**GE Hitachi Nuclear Energy**

MFN 08-243  
Supplement 1

Subject: Response to Portion of NRC RAI Letter No. 207 Related to ESBWR  
Design Certification Application - DCD Tier 2 Section 3.8 - Seismic  
Category I Structures; RAI Number 3.8-120 S01

**RAI Number 3.8-120 S01**

**Figure 3.8-120(1) Liner Response at Diaphragm Floor Connection, DBA Thermal Stress at 6 Minutes**

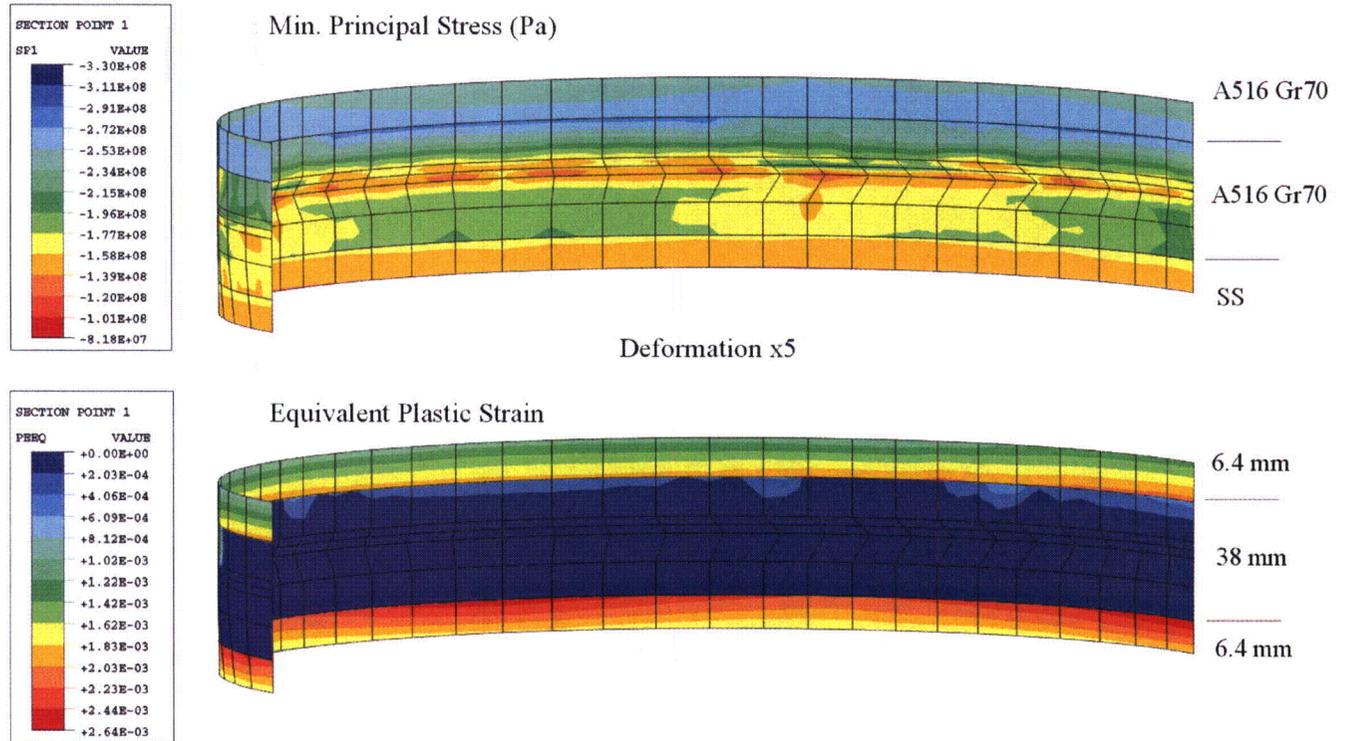
Figures 3.8-120(1) and 3.8-120(2) provide plots for the response of the liner materials at the Diaphragm Floor connection from the DBA thermal analysis at times of 6 minutes and 72 hours, respectively. These figures show contour plots for the Maximum Principal Stresses and the Accumulated Plastic Strain for the thickened sections and a part of the connected liners. General yielding in the 6.4 mm (1/4") thick liner material and some slight localized yielding in the 38 mm (1 1/2") thick section near the connection with the thinner liner develops by 6 minutes due to compressive stress as the liner gets heated relative to the RCCV concrete. Using A-709 for the thickened section would likely reduce or eliminate the yielding in the thickened section. However, because the extent of this yielding is localized and the magnitude of yielding is small (plastic strain of about .03%), this is considered to have a negligible effect on the section forces calculated across the complete RCCV wall near this region.

Figure 3.8-120(3) Liner Response at Vent Wall Connection, DBA Thermal Stress at 6 Minutes

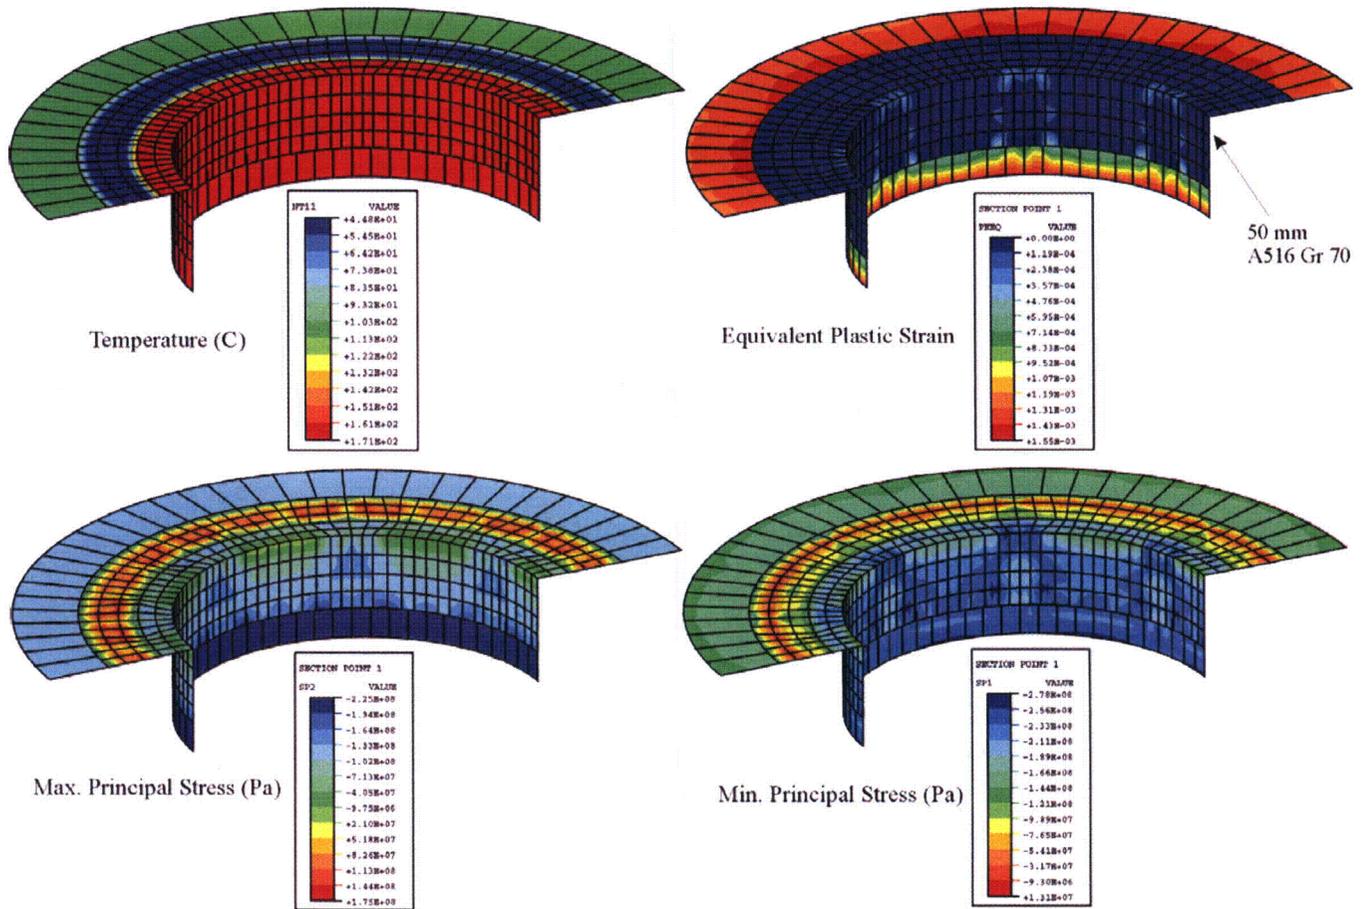
Figures 3.8-120(3) and 3.8-120(4) provide plots for the response of the liner materials at the Vent Wall connection from the DBA thermal analysis at times of 6 minutes and 72 hours, respectively. These figures show contour plots for Temperature, the Accumulated Plastic Strain, the Maximum Principal Stresses, and the Minimum Principal Stresses for the thickened sections and a part of the connected liners. Again, general yielding in the liners develops early due to compressive stresses, as the liner gets hot under the accident temperature history relative to the concrete. Here some slight localized yielding in the thickened section develops at the connections with the Reactor Pressure Vessel support brackets. Because of the localized extent and small amount of plastic strain in this thickened section, it is concluded that replacing the SA-516 material with the higher strength A-709 material will not significantly affect the thermal ratios calculated across the complete RCCV wall section near this connection.

Figure 3.8-120(5) Liner Response in Upper Drywell, Fragility Analysis, 500°F Median Values, Load Factor = 7

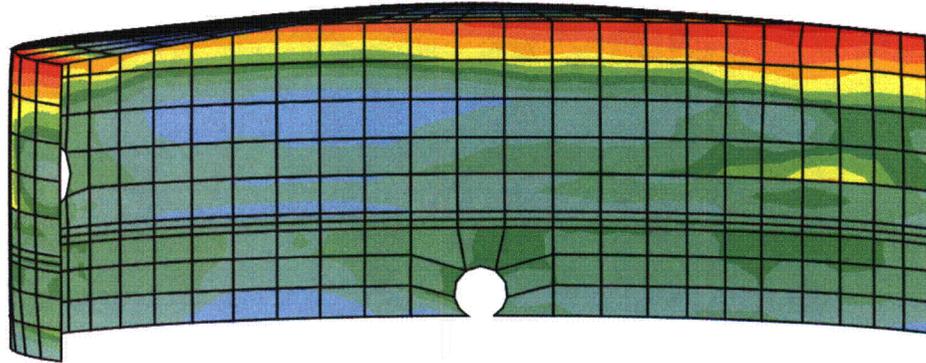
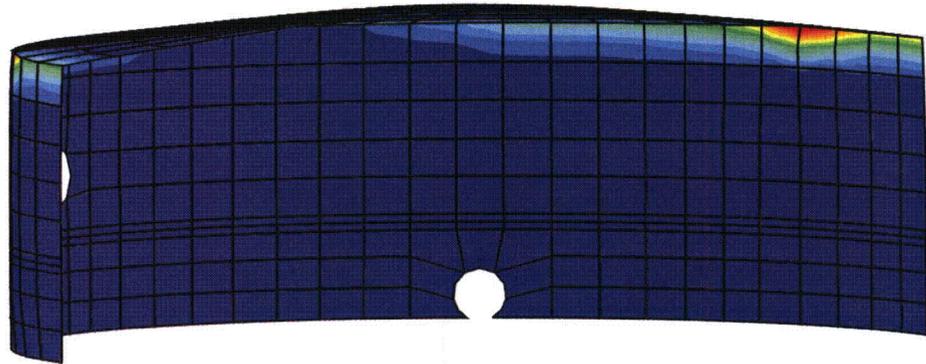
The Fragility analyses for ultimate capacity due to over-pressurization in DCD Tier 2 Appendix 19C determined that the tearing of the RCCV liner would occur first at the connection of the RCCV wall with the top slab. The Level C pressure capacity calculations, documented in DCD Tier 2 Appendix 19B, also identified that tearing of the liner at the connection of the RCCV wall with the top slab was the limiting factor for the Level C pressure capacity. An evaluation is performed to assess whether replacing the thickened portion of the liners with A-709 would affect this failure mode. Since the A-709 has higher yield capacity than the SA-516, the change will not affect the thickened portion directly. The assessment considers whether a lower ductility of the connection of the thinner liner to the thickened portion could shift the liner tearing mode from the RCCV wall to top slab connection to this connection at a lower internal pressure. Figure 3.8-120(5) plots contour plots for Maximum Principal Stress and Accumulated Plastic

Strain for the liners in the upper drywell at a load factor of 7 on design pressure for the median property analysis of the 260 °C (500 °F) steady state temperature condition. This plot shows that the yielding has not developed in the thickened portion or at the connection with the thickened portion at this load level. This pressure load is beyond that which causes tearing to develop in the liner at the connection of the RCCV wall and top slab. Figure 3.8-120(6), which is Figure 19B-4 extracted from DCD Tier 2 Appendix 19B, shows a similar plot for the liner response under the Level C analysis conditions. Again, the strains at the connections of the thinner liner to the thickened sections are much smaller than those at the RCCV wall to top slab connection, and changing the material of the thickened section would not cause the calculated Level C capacity to change due to a shifting of the failure location because of slightly lower ductility. Likewise, replacing the 50 mm (1 15/16") thick portion at the VW connection with A-709 will not affect the calculated limiting pressure due to liner tearing at the RCCV wall connection with the top slab. Therefore, replacing the thickened portions of the liner with A-709 material will not affect the calculations that have been performed for the pressure fragility nor the Level C pressure capacity of the RCCV.
